# Final Environmental Impact Report

SCH No. 2022090006

# 5355 East Airport Drive Project

City of Ontario, California

Figure 1: Trip Generation Rates for Different Warehouse Categories (Trips Per 1000 Square Feet per Day)<sup>29</sup>

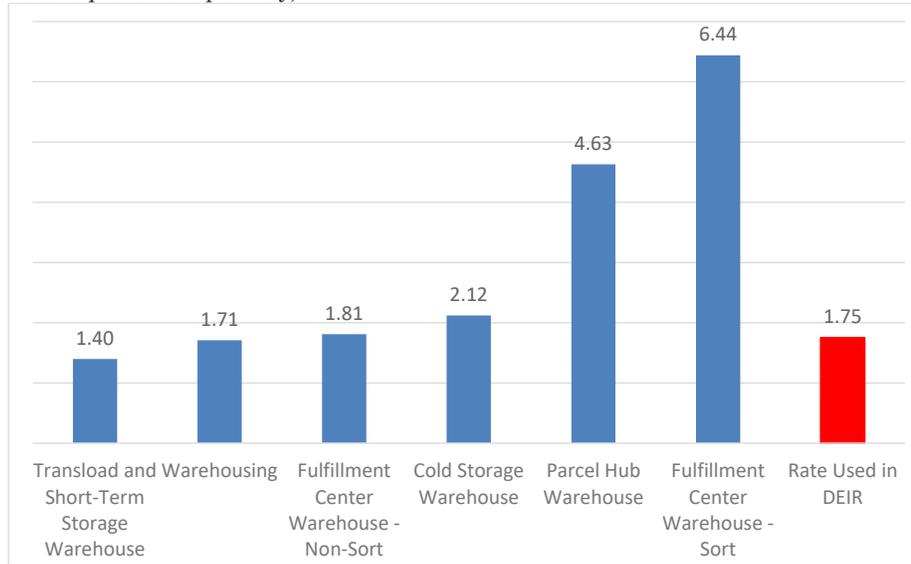
The DEIR fails to address why the other land use codes shown above are inapplicable to the Project. And the DEIR fails to provide sufficient information about the Project’s expected uses and configuration for the public and decisionmakers to ascertain which of these end uses are possible for the Project. This informational defect affects the entire DEIR, as different types of warehousing have different environmental impacts.

- A-6 The commenter first summarizes the trip generation assumptions used for the Project and provides a graph depicting trip generations rates for different warehouse categories. The commenter then asserts that the Draft EIR fails to address why other land use codes from the Institute of Transportation Engineers (ITE) Trip Generation Manual were inapplicable to the Project, that the land use code used for the Draft EIR underestimated the Project's GHG and VMT impacts, and that the Draft EIR should be revised by applying a significantly higher and more conservative trip generation rate, or requests as a condition of approval that trip generation will not exceed the number assumed in the Draft EIR.

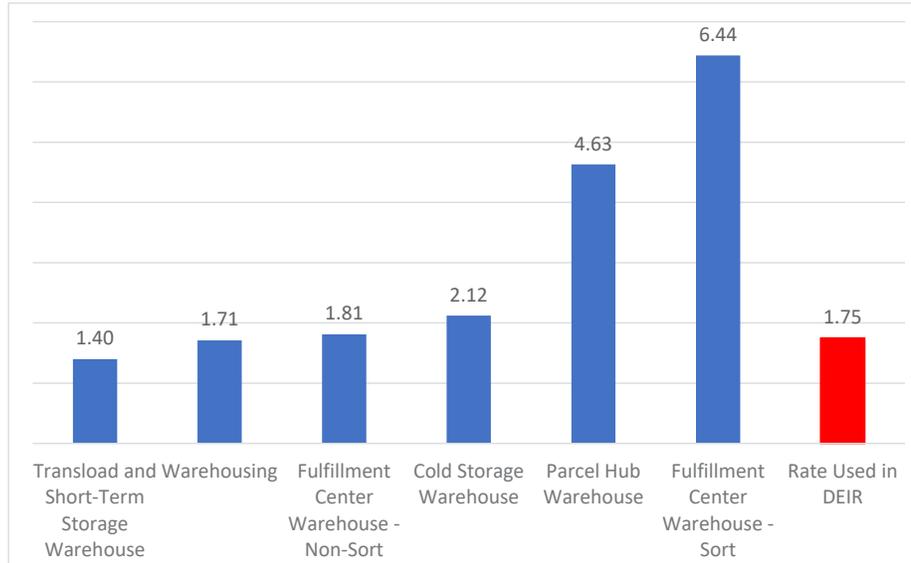
The DEIR estimates trip generation based on the rates in the Institute of Transportation Engineers (“ITE”) *Trip Generation* manual. *Trip Generation* includes other categories of warehouses. As shown in the figure below, the trip generation rates applied in the DEIR are much lower than rates for some other warehouse categories.

The observed trip generation rates at two of the parcel hub sites are even higher than the rates shown in the figure above.. As shown in the figure below, the highest trip generation rates were observed at two of the parcel hubs, with rates of about 14 trips per 1000 square feet per day, i.e., 8 times the rate used in the DEIR.

- A-27 The commenter summarizes the trip generation assumptions used in the Draft EIR and provides a graph depicting trip generations rates for different warehouse categories. The commenter then asserts that that the Draft EIR should be revised by applying a significantly higher and more conservative trip generation rate, or requests as a condition of approval that trip generation will not exceed the number assumed in the Draft EIR. Refer to Response to Comment A-6 regarding the applicability of different ITE land use codes to the Project. The most appropriate and reasonable ITE land use codes were applied in the Project's analyses. It would not be necessary or appropriate, nor does the City have the capacity to enforce the counting of vehicles traveling to and from the Project site, nor would any environmental improvements be achieved from such an exercise. Further, the SCAQMD has adopted and is enforcing Rule 2305 (Warehouse Indirect Source Rule) (refer to Draft EIR p. 4.2-20) that will require the warehouse operator to implement measures that reduce nitrogen oxides and particulate matter emissions and/or pay a fee to fund programs to improve regional air quality. Thus, no further response is required.

**Exhibit 11: Daily Trip Generation Rates at Parcel Hubs**

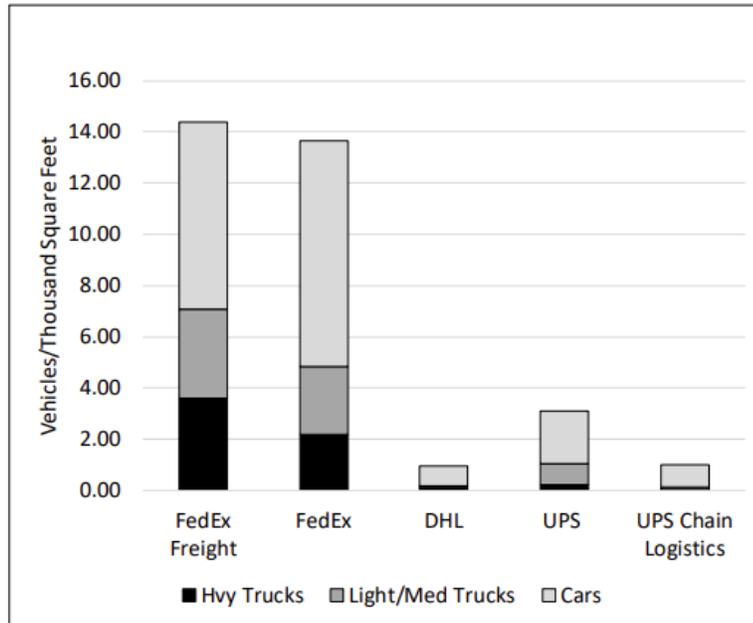
Given the large uncertainty in the project’s trip generation, the applicant should take one of two paths - either a) applying a significantly higher and more conservative trip generation rate, or b) requesting as a condition of approval that trip generation will not exceed the number assumed in the EIR, and this be certified prior to beginning construction.
